INTERIOR GLAZING

SALEM GLASS COMPANY

PROJECT	KIRKLAND & ELLIS	PROJ NO	8901
ARCHITECT	HO&K	DATE	WORKING
GENERAL CONTRACTOR	STRUCTURE TONE, INC	DRAWN	SM
		CHECKED	SB/MO
		FILE NAME	8109 c 1
		SCALE	NO SCALE
		SHEET NUMBER	C102

V1
OPEN JAMB
© BACK PAINTED GLASS
ARCH REF: NONE

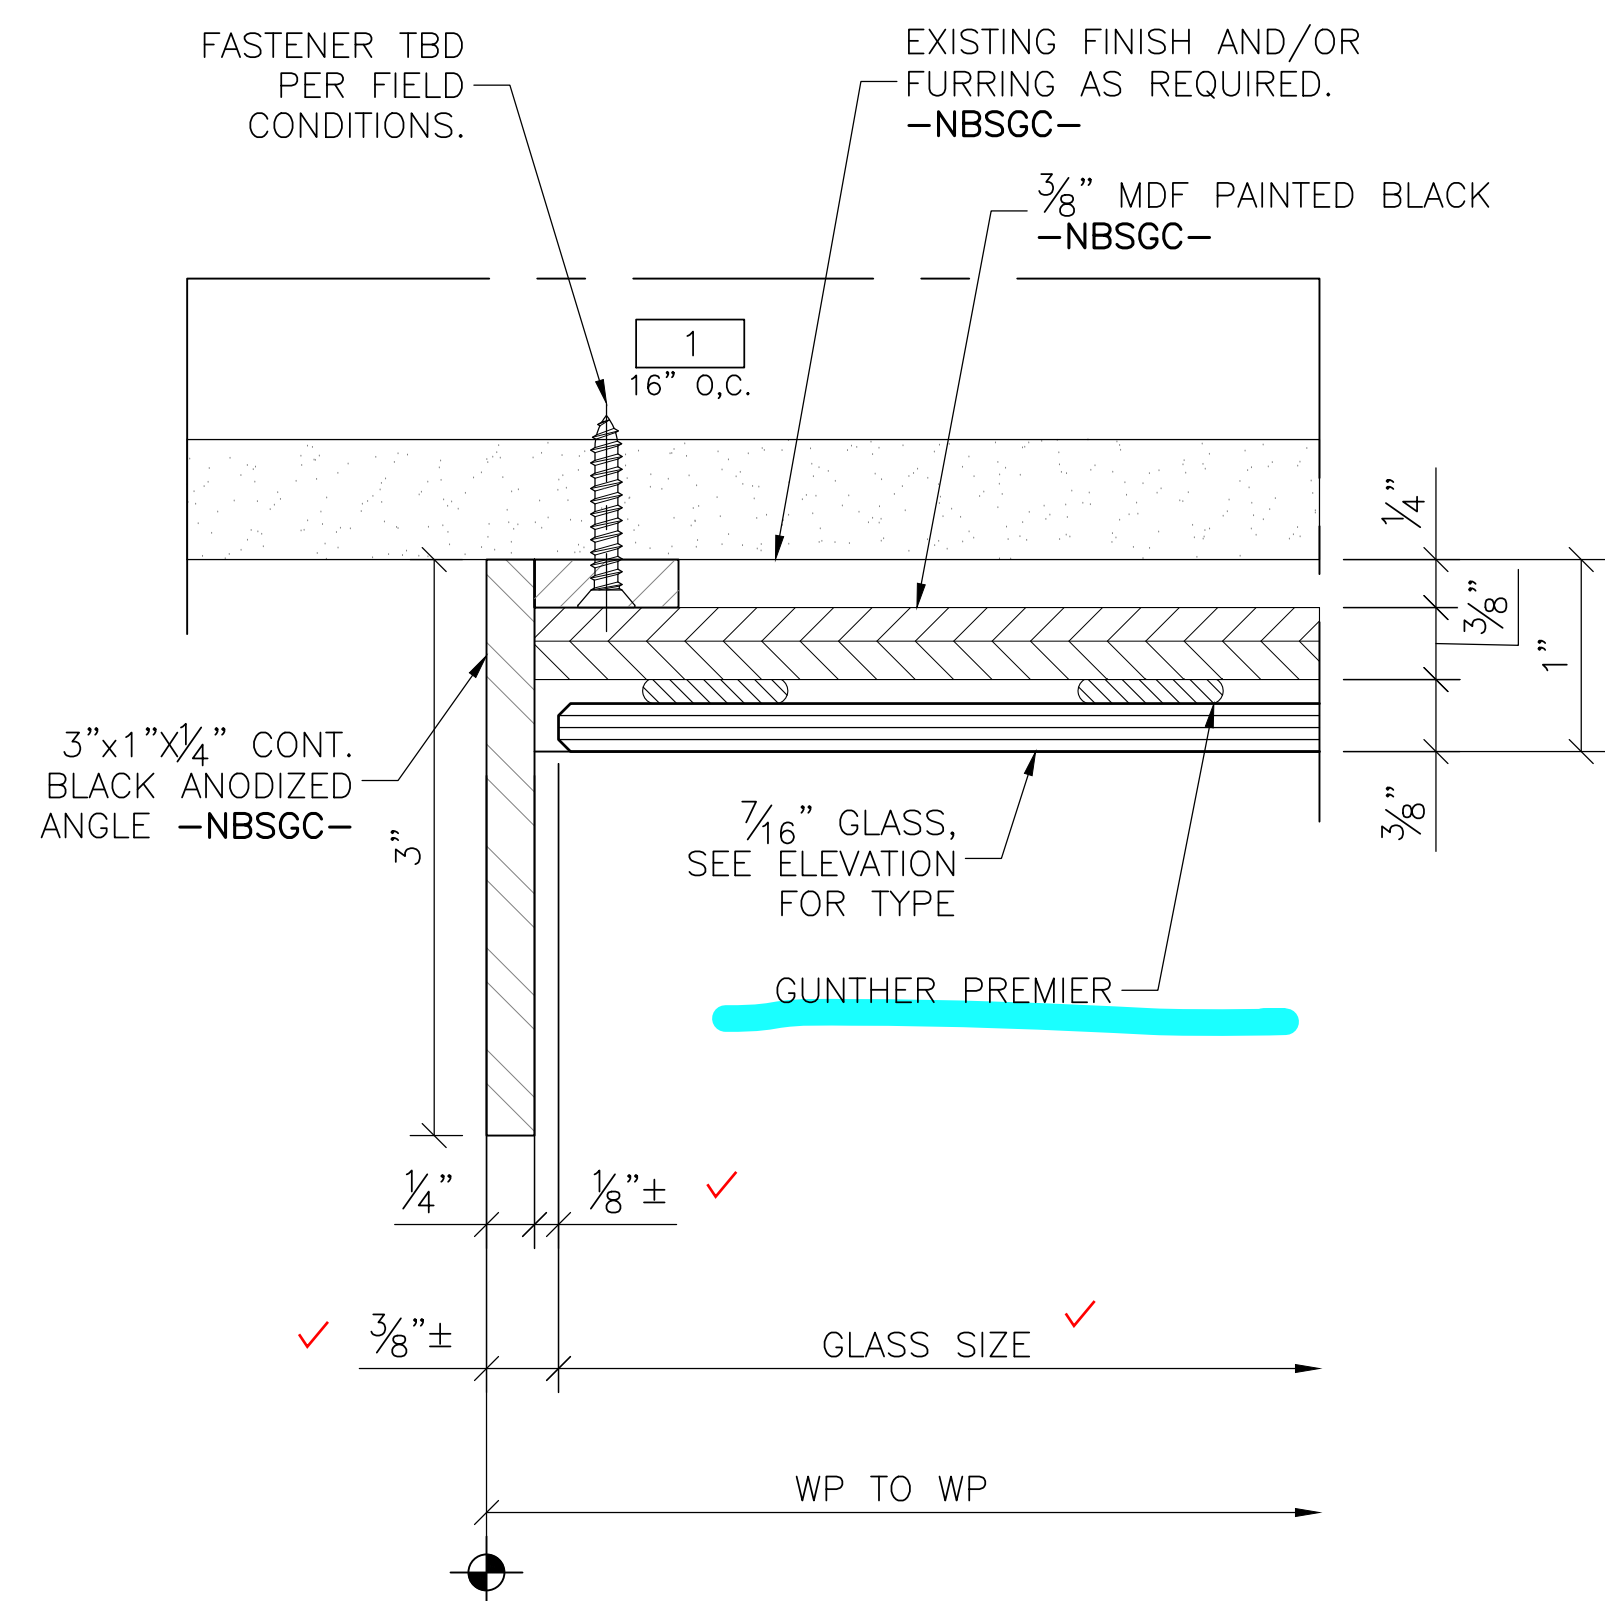
AT BACKPAINTED GLASS LOCATIONS ADHERED TO MDF, THE MDF SHOULD BE PRIME PAINTED ONLY IN A COLOR (LIGHT OR DARK) BASED ON THE BACKPAINTED COLOR. THE PERIMETER WALLS SHOULD BE PAINTED THE FINISH WALL COLOR TO AVOID READ THRU OF THE PRIMER.

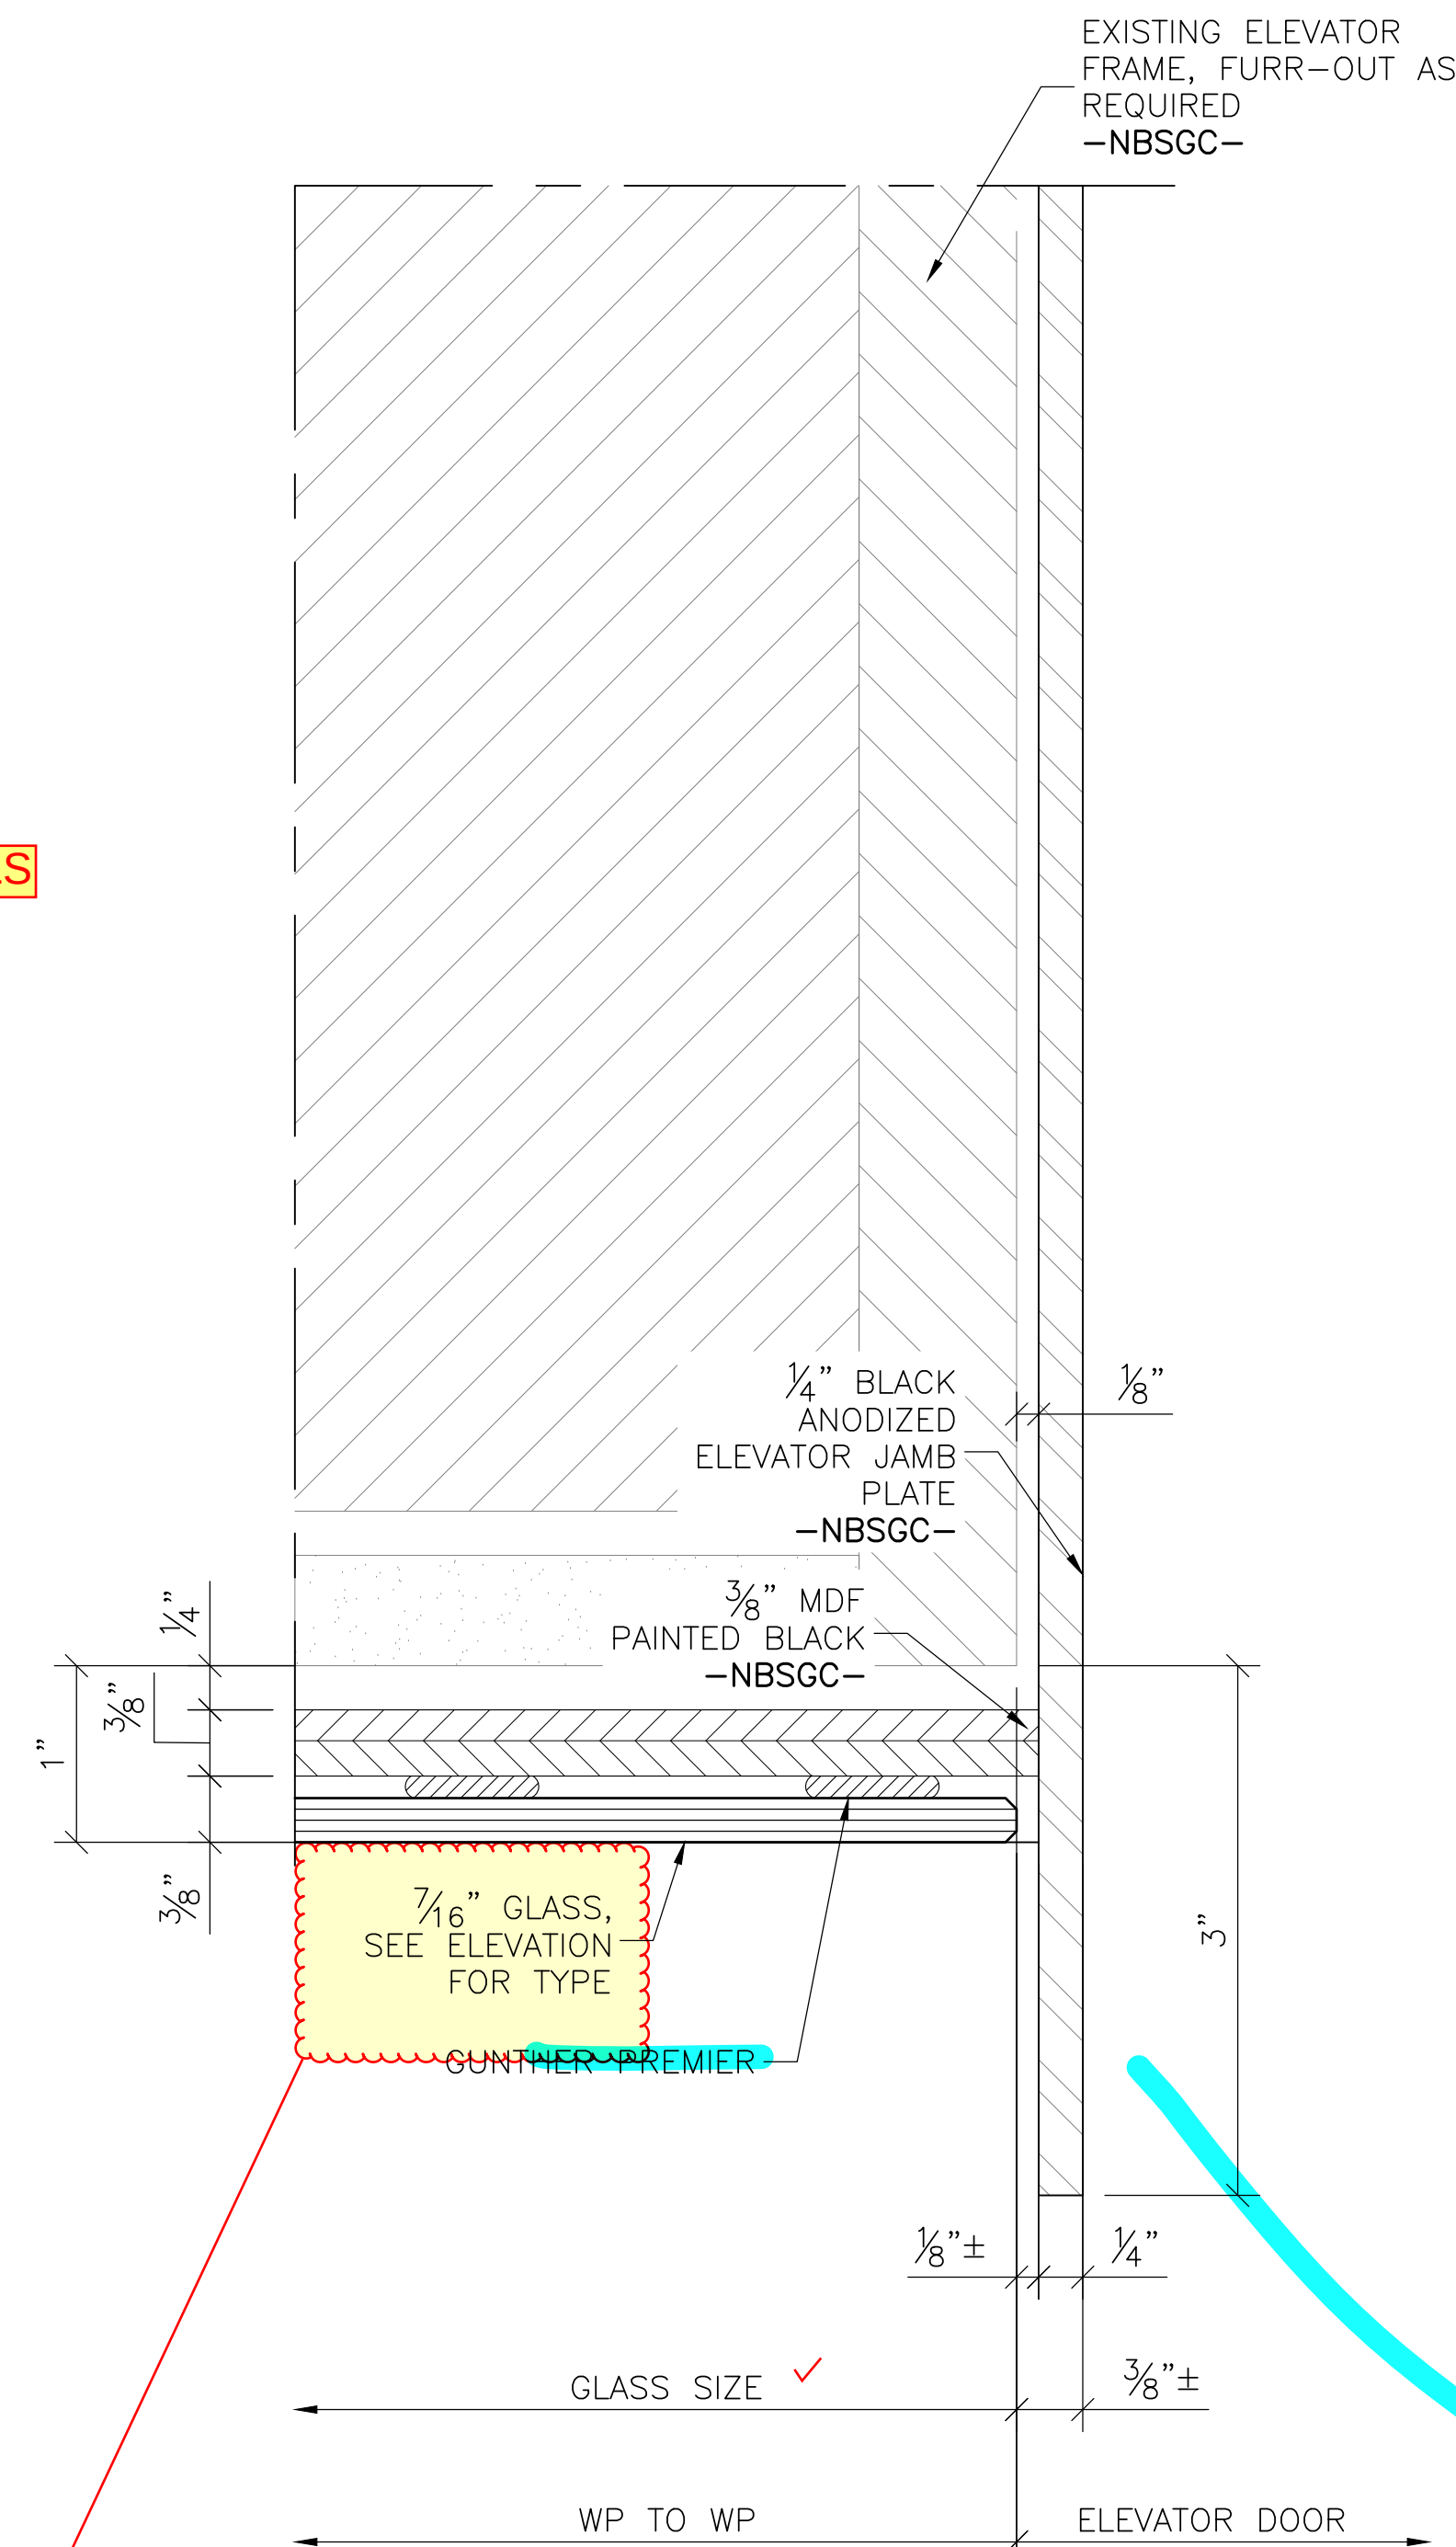
THIS IS THE WRONG GLASS BLOCK.
USE EITHER THE LAMI BLOCK OR SET
FOR 3/8" NOT 1/4". TYP ALL RELATED
DETAILS. THIS WILL CHANGE YOUR
DEPTH OF CONSTRUCTIONS.
